Lee's Summit Plan Review
220 SE Green Street
Lee's Summit, Missouri 64063
816-969-1200

RE: CITY COMMENTS FOR PRCOM20231142

Everstead Engineering & Design, LLC has updated the above-mentioned property construction documents per city comments as follows:

GENE INSOGNIA
TENANT FINISH
3512 SW MARKET ST
LEES SUMMIT, MO 64082

G202

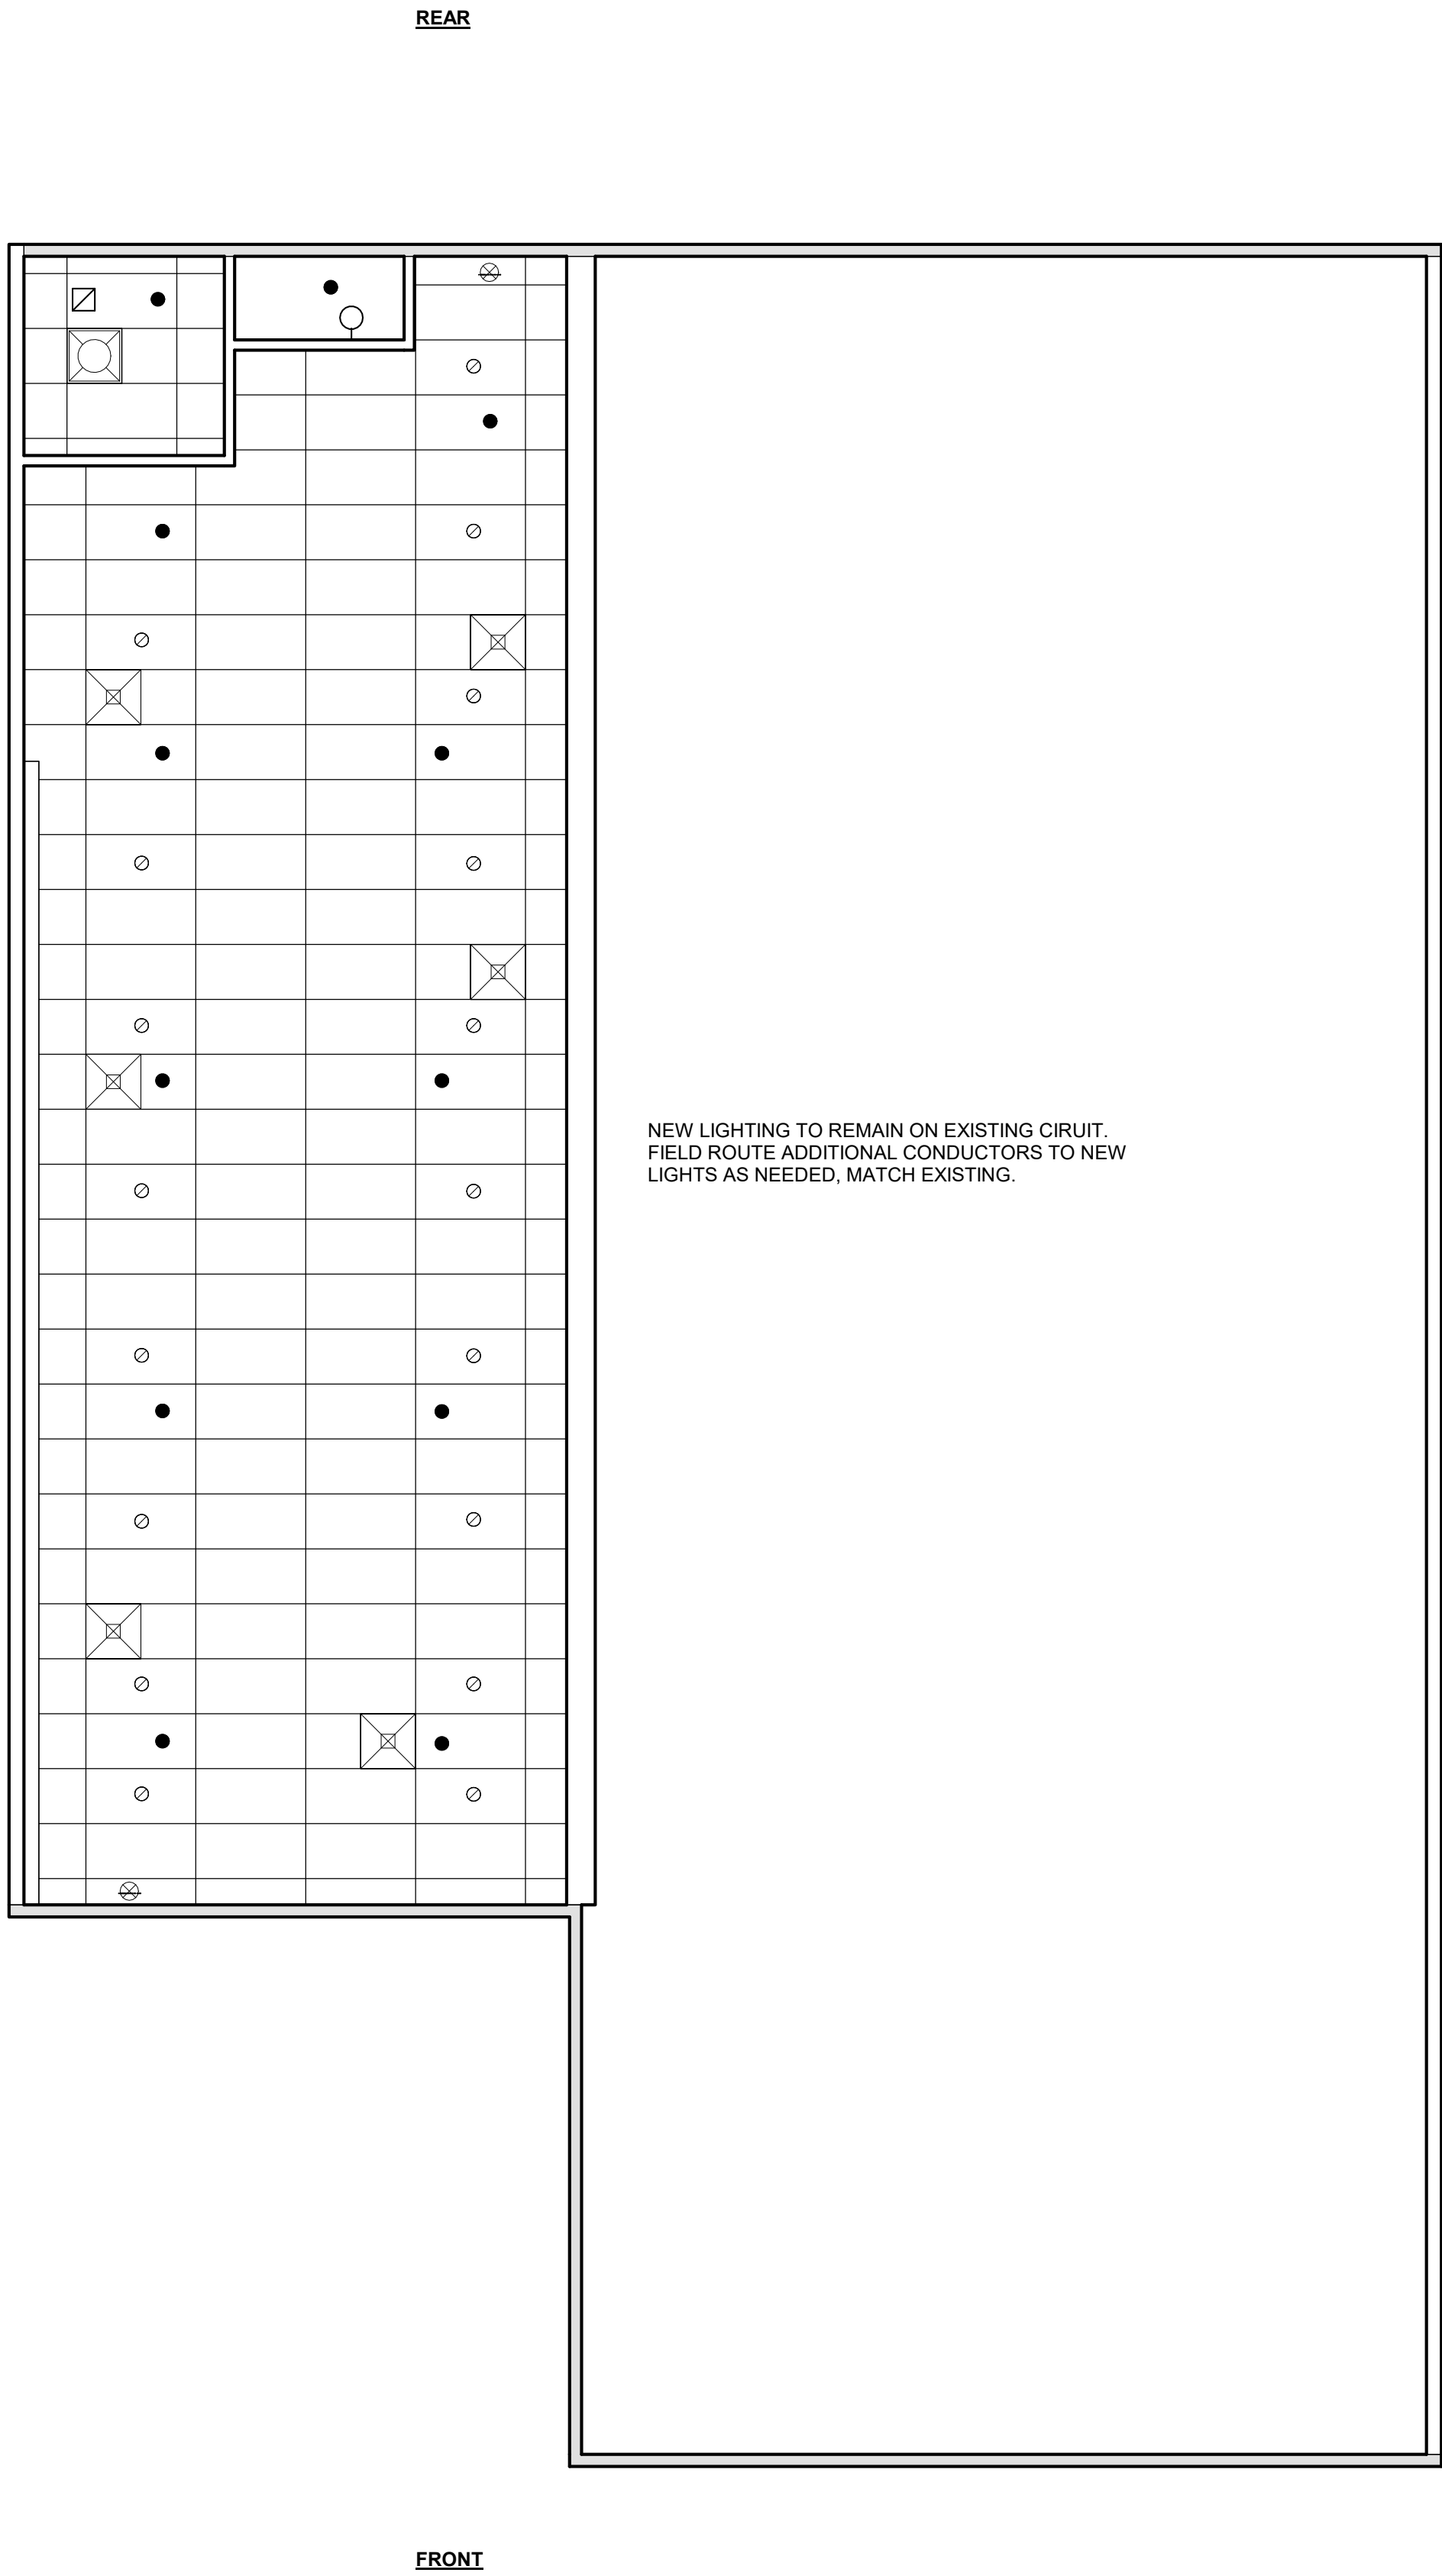
City Comment #4 "2018 IBC Exit Signs 1013.1 Where Required. Exits and exit access doors shall be marked by an approved exit sign readily visible from any direction of egress travel. The path of egress travel to exits and within exits shall be marked by readily visible exit signs to clearly indicate the direction of egress travel in cases where the exit of the path of egress travel is not immediately visible to the occupants. Intervening means of egress doors within exits shall be marked by exit signs. Exit sign placement shall be such that no point in an exit access corridor or exit passageway is more than 100 feet or the listed viewing distance for the sign, whichever is less, from the nearest visible exit sign. (see code section for exceptions)."

City Comment #4 "Provide Exit lighting over the cased opening from the new to the existing space."

Engineer's Response – Existing illuminated exit sign shown in reflected ceiling plan on G202, previously submitted. Emergency wall lighting added to plan, see G202.

Engineer's Response – Emergency wall light has been added over the cased opening, shown on G202.
